Access Compliance Report

Public Rights-of-Way

(Curb Ramps)

Intersection ID: 44166	Main Street: COCHRANE_DR	Cross Street: PAWPAW_LN	Location: NE
ADA ID: 3D6342C1F201	Ramp Type: PerpDiag	Initial Pass/Fail: Fail	Overall Compliance: No
			Severity Score: 21.25

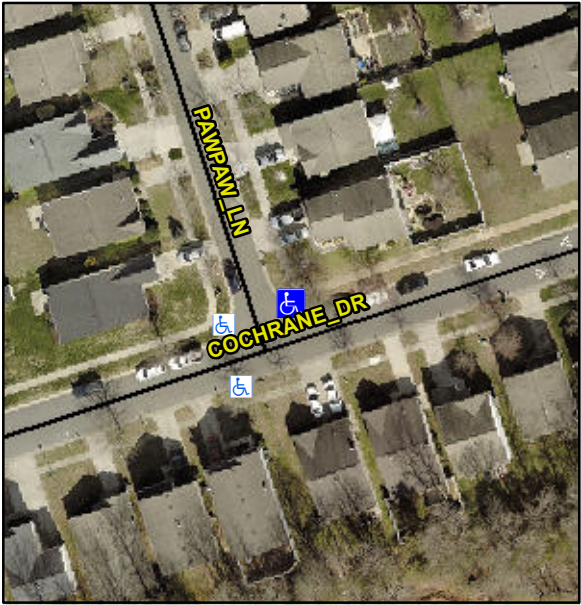
Codes/Mitigation Info/Possible Solution			Field Measurements/Component Compliance		
	Possible Solutions:		Compliance	Description	Data
	Remove & Replace Curb Ramp With Two New Directional Ramps or Equivalent.		No	Ramp Length (in)	81.0
			No	Ramp Width (in)	45.0
			N/A	Flare Type LT	N/A
			N/A	Flare Slope LT (%)	N/A
			N/A	Flare Traversable LT?	N/A
			N/A	Landing Length (in)	N/A
			N/A	Landing Width (in)	N/A
			N/A	Landing Slope (%)	N/A
			N/A	Landing X Slope (%)	N/A
<p>Surveyor Notes:</p> <p>N/A</p> <p>PROW/ADA:</p> <p>Not Found, R304.5.1, R304.2.2</p>			N/A	Flare Type RT	N/A
			N/A	Flare Slope RT (%)	N/A
			N/A	Flare Traversable RT?	N/A
			N/A	DWS Provided?	N/A
			N/A	DWS Contrast?	N/A
			N/A	DWS Length (in)	N/A
			N/A	DWS Full Width?	N/A
			N/A	DWS Offset (in)	N/A
			N/A	Gutter Ponding?	N/A
			N/A	Gutter Lip Ht (in)	N/A
			No	Painted X Walk1?	No
				X Walk 1 Direction	To W
			N/A	X Walk 1 Width (in)	N/A

0.4	X Walk 1 Slope (%)	0.1
			0.8	X Walk 1 X Slope (%)	0.4
			N/A	Ramp inside XWalk1?	N/A
			0.4	Road Slope (%)	N/A
			0.4	Road X Slope (%)	N/A
			N/A	Any Obstructions?	N/A
				Obstruction Type	
			N/A	Clear Space?	N/A
			N/A	Clear Space to XWalk (in)	N/A
			N/A	Storm Grate/Utility Hazard?	N/A
				Storm Grate/Utility Type	
			N/A		N/A
			Yes	Surface Condition? (G/P)	Good
Total Cost:		\$ 3200.00
